The main distinguishing feature of a hammer-head bolt with a head rounded on one side, Form B according to DIN 25192, compared to a hammer-head bolt according to DIN 261, is the radius.

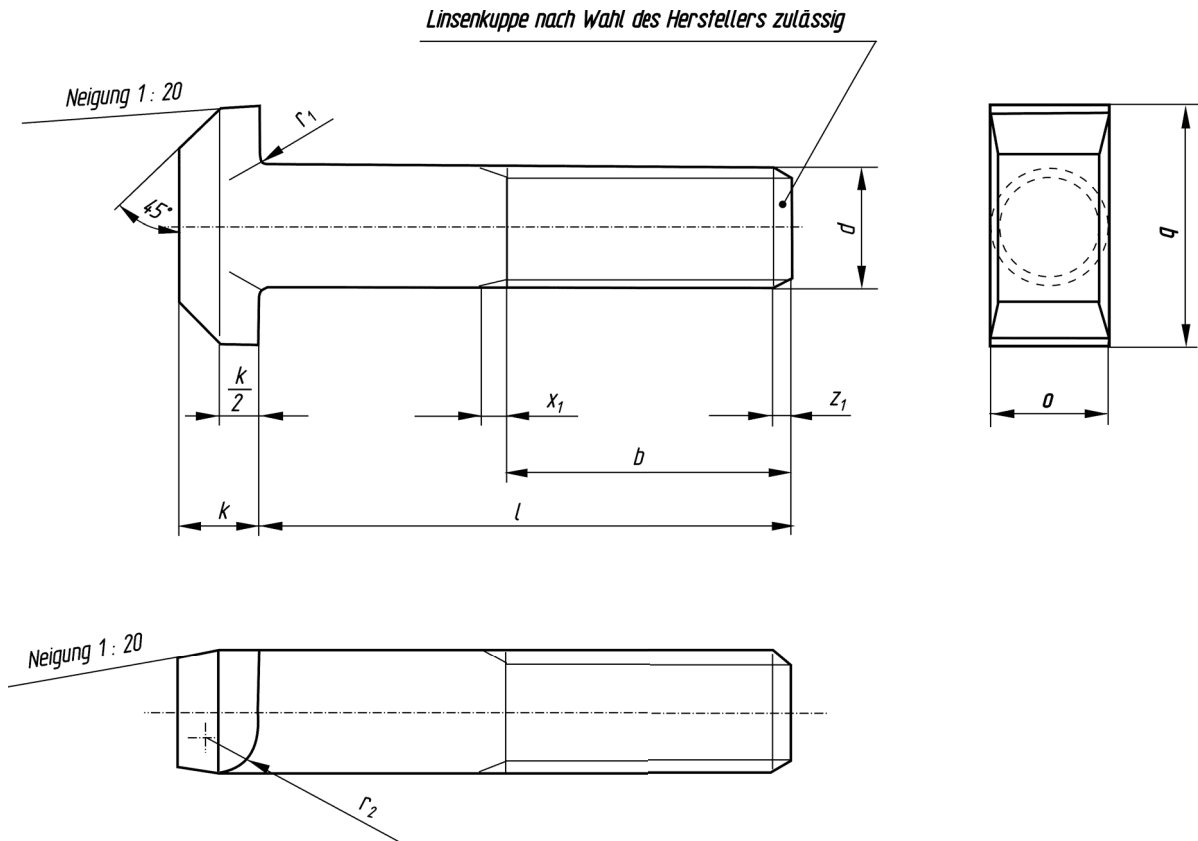
In the revised standard, this radius is shown in the wrong location and therefore represents a completely different bolt from a functional point of view.

Images 001a and 001b shall be replaced with the following images:
